ASSESSMENT REPORT

Commercial and Retail Development – Mount Street, North Sydney MP 08_0241 MOD 5

This report is an assessment of a request to modify the Concept Approval MP08_0241 for a commercial and retail development at 86-96 and 100 Mount Street, North Sydney.

Figure 3: Approved (left) and proposed (right) external alterations to the northern, Spring Street, elevation (source: Proponent (MOD 4 and MOD 5))

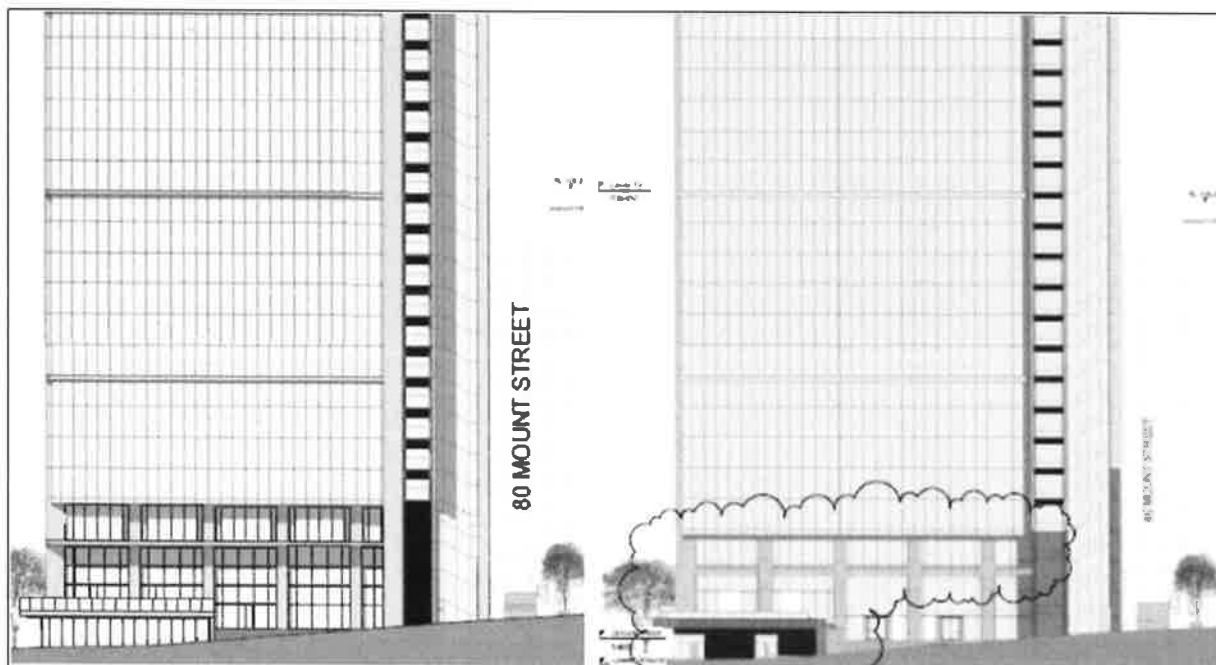
These changes can be seen in **Figures 5 – 8**. The above changes also result in alterations to the façade treatment of the building at ground, first and second floor levels, as shown at **Figure 3**.

Figure 4: Approved (top) and proposed (bottom) section through roof levels, indicating the proposed increase of 400mm in roof height (source: Proponent (MOD 4 and MOD 5))

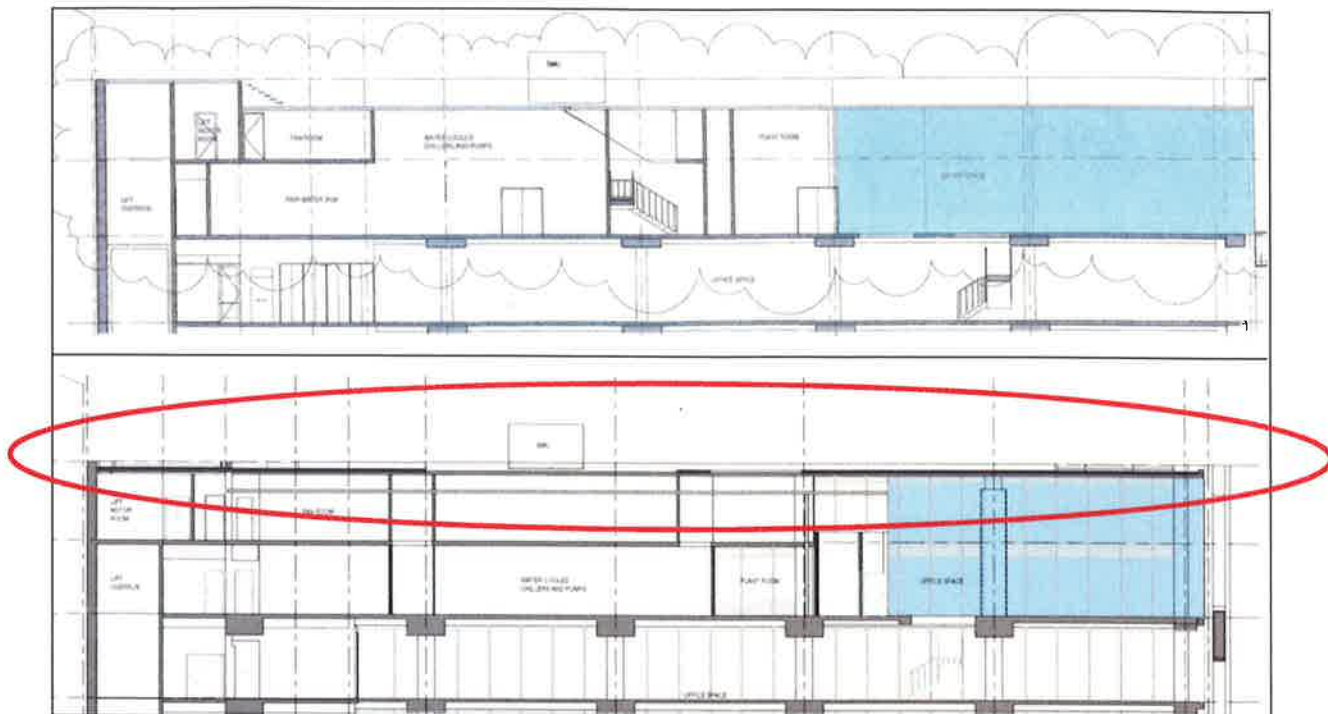
Issue	Consideration	Recommendation
<i>Increase in height</i>	- The modification includes an increase in the height of the roof level to match the height of the external parapets (refer to Figure 4). This also results in a corresponding increase in the height of the building maintenance unit (BMU) above the overall building height (from RL 199.70 to RL203.1). - Although the proposal exceeds the maximum height control of RL 195 applicable to the site under <i>North Sydney Local Environmental Plan 2013</i>, the Department considers the proposed increase is minor and acceptable as: - the increased roof height would be entirely screened behind the approved parapet line; - the BMU is centrally located within the roof and would not be visible from the surrounding streets or public domain; - the modification would not result in adverse overshadowing or view loss impacts; and - Sydney Airport has not raised any objection to the minor increase in height and has approved the penetration into the prescribed airspace.	No additional comments or amendments necessary.

Figure 5: Approved (top) and proposed (bottom) lower ground floorplan

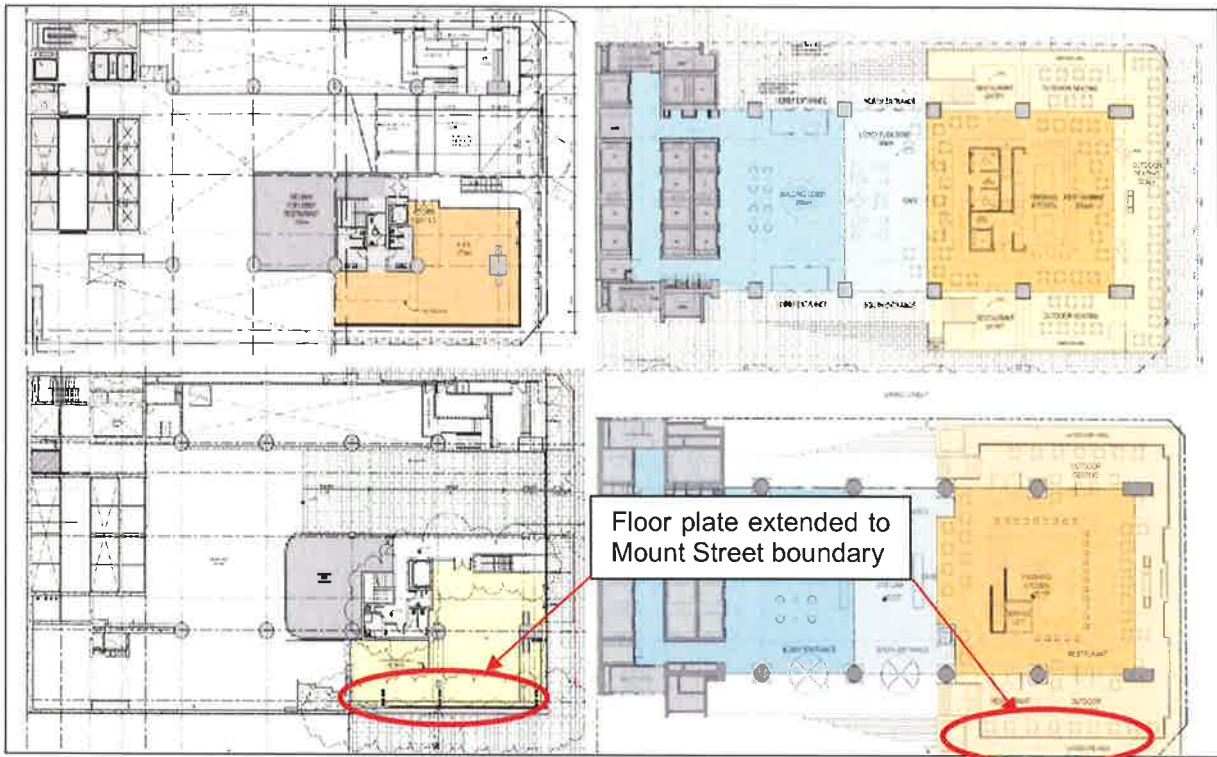
- enlargement of the ground floor level restaurant (and outdoor seating area) and lower ground level retail tenancy by extending the footprint to the Mount Street Boundary;
- provision of new plant room at level 1 and corresponding reduction of office accommodation at this level; and
- enlargement of level 1 mezzanine floorplate, rename as 'level 2', convert use of level from plant to office space.

- the additional GFA is minor, localised at ground and second floor levels, and does not significantly change the overall bulk and scale of the approved development;
- the extension of the ground levels to the Mount Street boundary is consistent with Council's DCP, which recommends a nil setback for building podiums;
- the revisions to the elevations maintain a high standard of design and appearance;
- there would be no significant amenity impacts on surrounding properties; and
- the additional office and retail floor space positively contributes to the growth of North Sydney's CBD as a commercial centre.
